First reply to Referee 1's review of the AMTD paper

**” Detailed characterisation of AVHRR global cloud detection performance of the CM SAF CLARA-A2 climate data record based on CALIPSO-CALIOP cloud information”**

**Karl-Göran Karlsson and Nina Håkansson, SMHI**

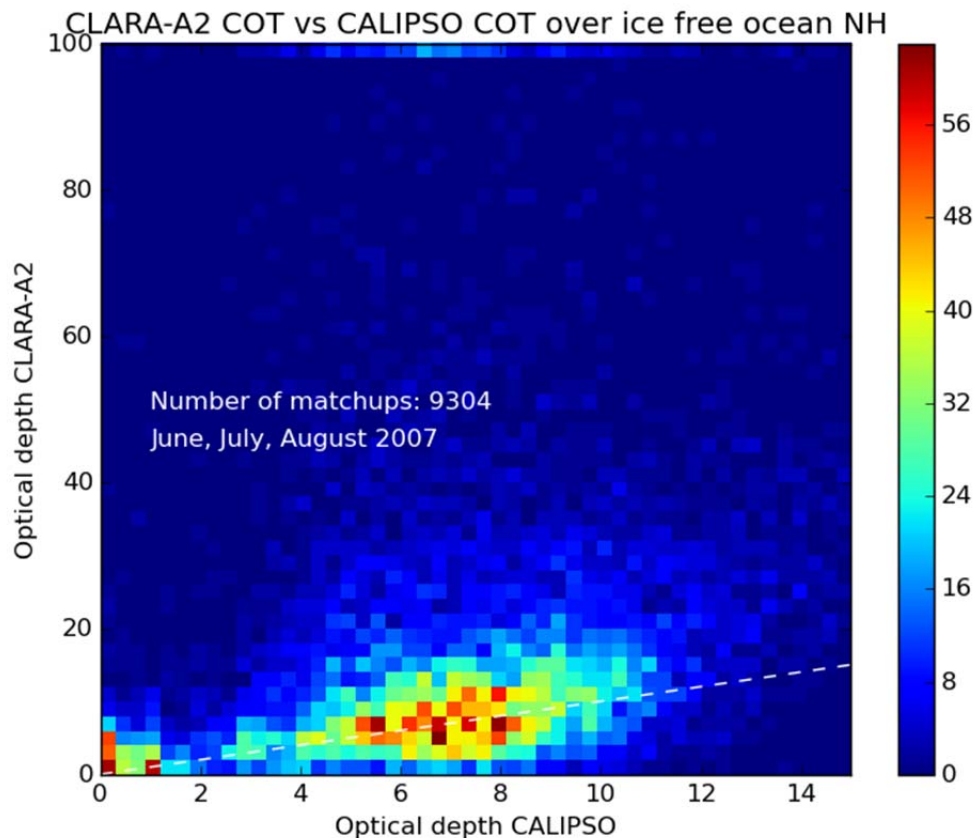
**p5, 1187: The optical thickness threshold of 5 for CALIPSO is higher than usually assumed. If it is necessary for this study to work with such a high threshold, it should be justified, and it should be explained how this is possible (referring to literature where this has been done, or with a dedicated sub-section in this manuscript where it is shown that the lidar does, in fact, allow to go to COD 5, and under which circumstances).**

We admit that we do not have good support in the literature for stretching the useful upper limit of CALIPSO-derived COD to 5. However, in the description of the upgrade to CALIPSO-CALIOP version 4 it is also emphasized that previous cloud optical thicknesses in version 3 were generally underestimated. This is also clearly indicated in Figure 2 in the manuscript. Whether this increase entirely justifies moving the upper limit to 5 is still not clear.

We do have more indications from our own investigations that an adjustment of the upper limit seems possible. In a study related to a paper by Riihelä et al (2017) we investigated the correlation between CALIPSO-estimated and CLARA-A2 estimated CODs over various surfaces (with snow surfaces over Greenland as the main target). However, when isolating the collocated results over ice free ocean surfaces at high latitudes (noting that over a dark surface also the AVHRR-based estimations should be more accurate), we could clearly see a good correlation between the two estimations up to about COD=5 (see figure below):

Although this is not a perfect illustration (not included in Riihelä et al, 2017, but maybe considered for a follow-up paper) it shows how CLARA-A2-estimated optical depths compare to CALIOP-estimated optical depths in the range 0-15. Over a dark ocean surface the majority of values agree pretty well but what is clear is that an increasing number of cases (for higher optical depths) CLARA-A2 values saturates at 100 for CALIOP-values exceeding approximately 4 (noticeable at top of the figure). This reflects the inability of CALIOP to provide reasonable optical thicknesses for optically thick clouds. But, we made the conclusion that values compare pretty well even up to an optical thickness of 4-5 and this was one of the reasons why we decided to use the CALIOP interval 0-5 for this particular study (for AMT).

We propose that we keep the original maximum value of 5 in our plots but add a remark that values near this upper end are uncertain. The upper limit is not crucial for the findings of our study since in most cases the cloud detection sensitivity is considerably lower than 5. Only for some positions over Greenland

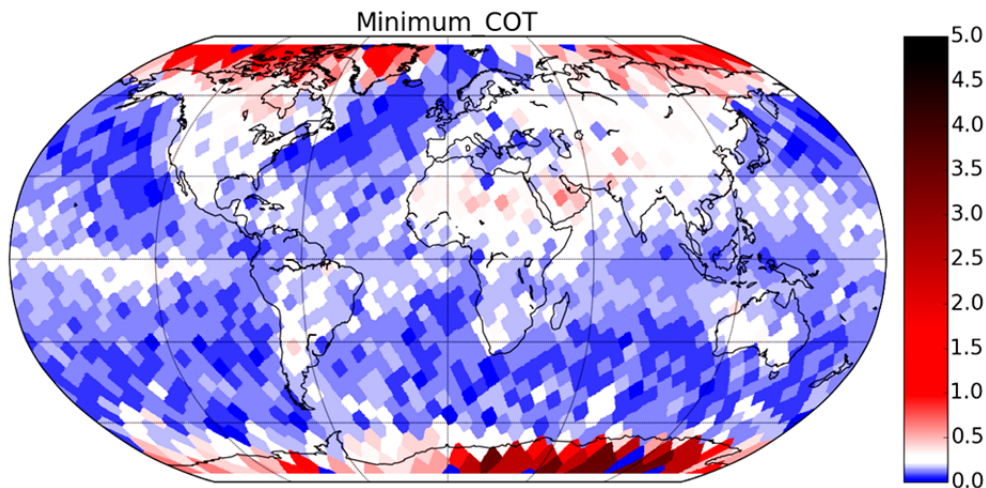
**p9,l355-359: Add explanation why AVHRR gives higher cloud cover. It is easy to imagine a scenario where small cumulus clouds would be picked up by AVHRR (even if below its spatial resolution), but not by CALIOP**

However, the results in Figure 7 illustrate a more general problem. One has to remember that all results in Figures 6-10 are based on comparison with a CALIOP cloud mask filtered at cloud optical thickness 0.225 (the latter being the global mean cloud detection sensitivity). But regionally, the value of the cloud detection sensitivity varies a lot (see Figure 11). We actually propose to change Figure 11 so that the relation to the mean value of 0.225 is made clearer. This is what we have in mind:

In this plot all values below the mean value 0.225 are plotted in blue colours and values above 0.225 in red colours. This colour representation also indicates better the highest values in the polar areas (not properly visualized in the current Figure 11).

Notice here that most oceanic areas are coloured blue and that the positive bias in Figure 7 is also mostly occurring over oceanic areas. By using a CALIOP cloud mask with cloud optical thickness being cut at 0.225 as our validation reference, we are then ignoring a substantial fraction of originally detected clouds below this cloud optical thickness limit over ocean surfaces. But these clouds are to a large extent actually detected in the CLARA-A2 results. Thus, it leads to an apparent overestimation of cloudiness over ocean in Figure 7 (notice that we are filtering CALIOP data and not CLARA-A2 data). This illustrates how difficult the estimation of general validation scores really is. More clearly, regardless of using a filtered CALIOP cloud mask or not when validating, there are always disadvantages. In that sense, the results expressed by the globally resolved cloud detection sensitivity is a much more objective visualization of the cloud detection performance provided that also a separate evaluation of false alarm rates are made. We repeat the following statement from section 3.4 (lines 295-300): “An important additional or complementary parameter in this context would be the false alarm rate in the unfiltered case ( $FAR_{cloudy}(\tau=0)$ ) since this parameter is not depending on any filtering of thin clouds”. We will add this as an important result and recommendation in the Conclusions section.
